RE: CLIFFORD WEST CHURCH (K-10/D37)
(8570 Saul Bell Rd) (AKA: Fellowship Missionary Baptist Church)
ENGINEERS CERTIFICATION FOR CERTIFICATE OF OCCUPANCY
ENGINEERS STAMP DATED 7/25/2001
ENGINEERS CERTIFICATION DATED 8/28/2002 Rev. 9/25/2002

RE: CLIFFORD WEST CHURCH, Clifford West Business Park Unit 1 (K10-D37). Revised DRAINAGE REPORT, Revised GRADING AND DRAINAGE PLAN FOR SITE DEVELOPMENT PLAN FOR BUILDING PERMIT, GRADING PERMIT, AND BUILDING PERMIT APPROVALS. ENGINEER'S STAMP DATED JULY 12, 2001.

CLIFFORD WEST CHURCH

**RE: REVISIONS TO THE APOSTOLOC ASSEMBLY GRADING AND
DRAINAGE PLAN**

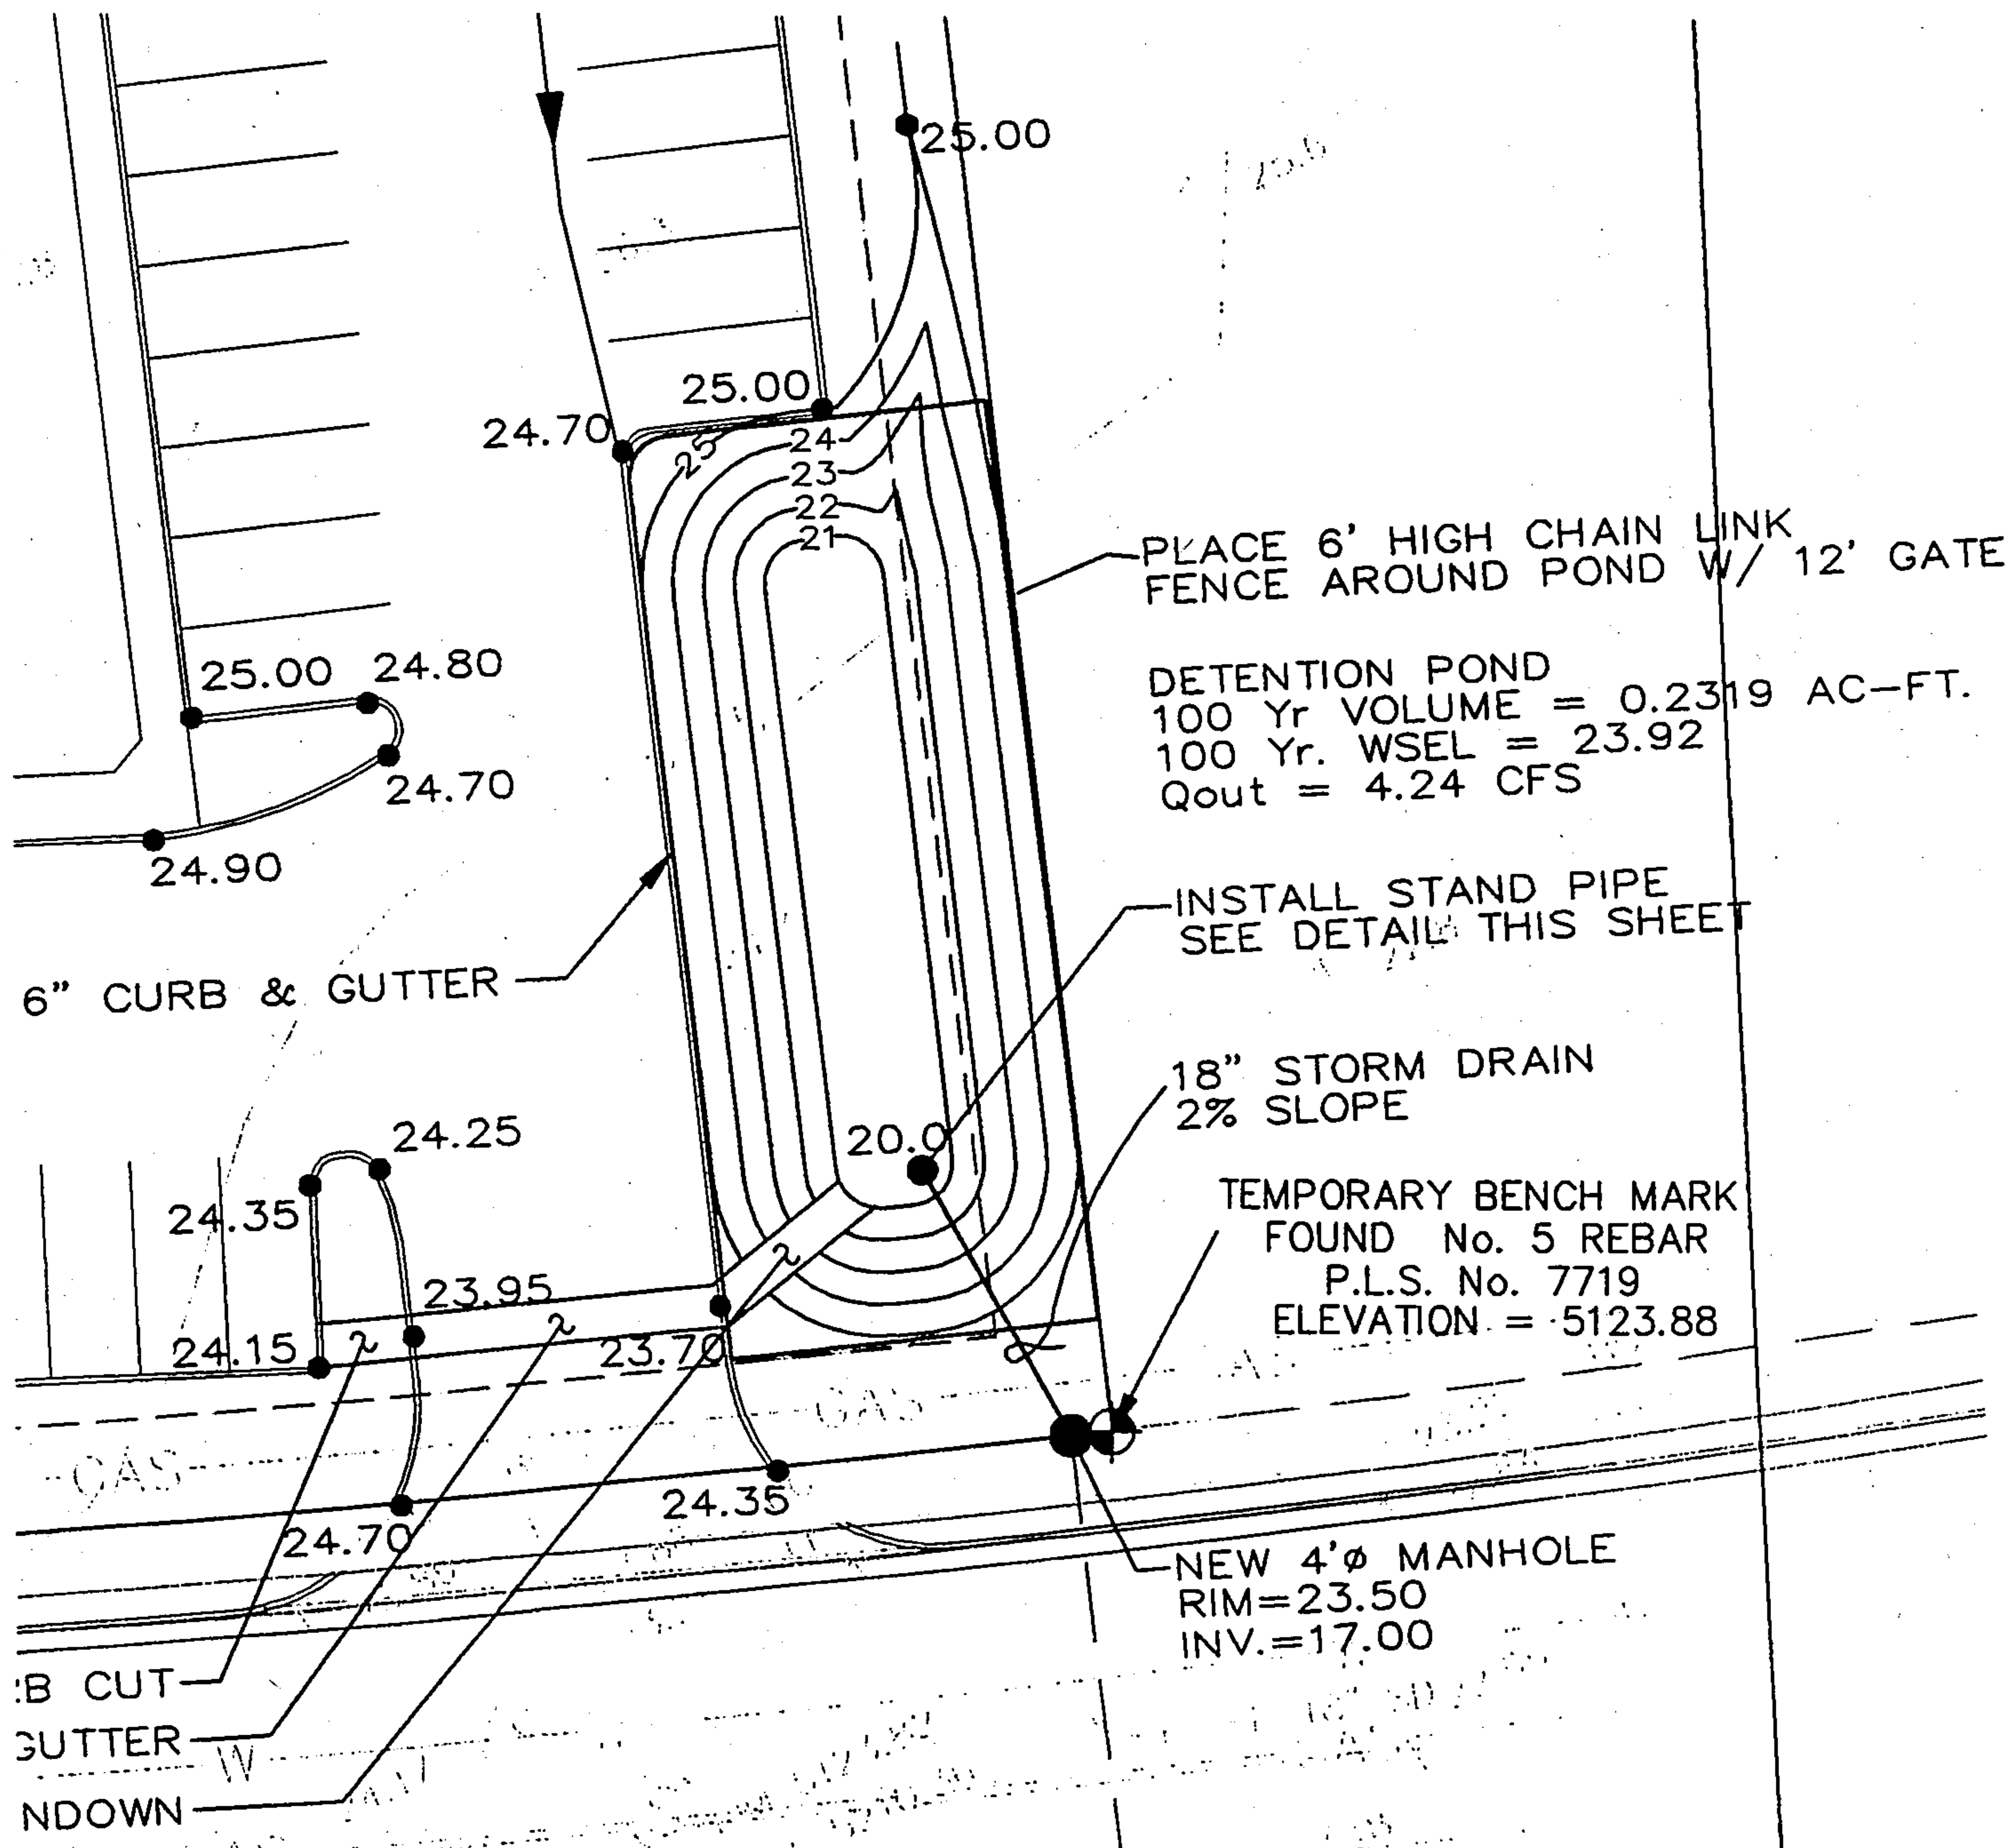
Enclosed are the revisions to the Apostolic Assembly (AA) Grading and Drainage plan to accommodate flows from the Clifford West Church (CWC) site to the north. I obtained the information from the CWC Grading and Drainage plan and input their AHYMO model into the AA AHYMO model. The standpipe was modified to allow more flow out of the detention pond on the AA site. The total flow out of the pond is 4.24 cfs, which is equal to the allowable discharge from the two sites. This was accomplished by modifying the size and number of holes in the standpipe to 5-3" holes with one-foot intervals. The detention pond volume was increased from 0.2264 acre-feet to 0.2319 acre-feet. The 100-year water surface elevation was changed from 23.85 to 23.92, which allows for 1.08 feet of freeboard.

Based on the information submitted on 4-24-02, the modification to the outlet of the detention pond is approved for Building Permit.
